Supplement Authorization Form

Project Title: [redacted] **PILC Cable Replacement**	**Project Number: CD01333**
Date Prepared: 03/05/2026	**Company:** Eversource CT
Organization: Distribution Engineering	**Project Category:** UG CABLE & EQUIPMNT REPLACEMNT
Initiating Organization: Distribution	**Project Type:** Specific
Project DDE: [redacted]	**Capital Investment part of 5-year plan?** Yes
Project Manager: [redacted]	**Emergency Related Request?** No
Project Sponsor: [redacted]	**Facility Type** (check all that apply)**:** ☐ PTF ☐ non-PTF ☒ Distribution ☐ N/A (General Plant)
Current Authorized Amount: $2,432.0K	**Approved In-Service Date:** 12/31/2025
Supplement Request: $ 232.5K	**Estimated In-Service Date:** 12/31/2026
Total Capital Request ($): $2,664.5K	**Authorization Type: Supplement Request**
	Reason: : Scope Change

This project is being revised due to a change in scope with regard to the amount of PILC conductors to be replaced, as a result of a subsequent field survey that was performed on this circuit. An additional 1,173' of PILC cable was discovered upon inspection. This additional cable was not included in the original scope because the GIS had indicated that it was

Map showing additional scope:

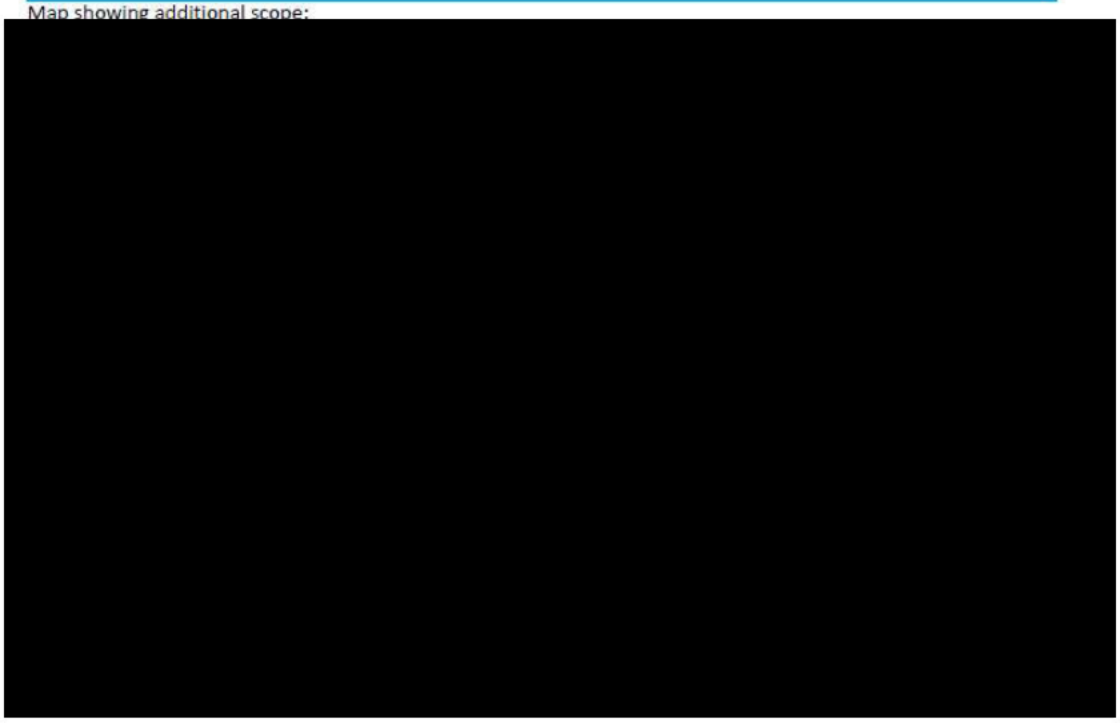
- $197.8K - Change in scope. An additional 480' of PILC cable was identified as requiring replacement that was not included in the original estimate. This was because the GIS system incorrectly indicated that the cable in question was 4/0 Cu 4CT cable instead of PILC cable. The additional cable was identified during pre-construction field visits.
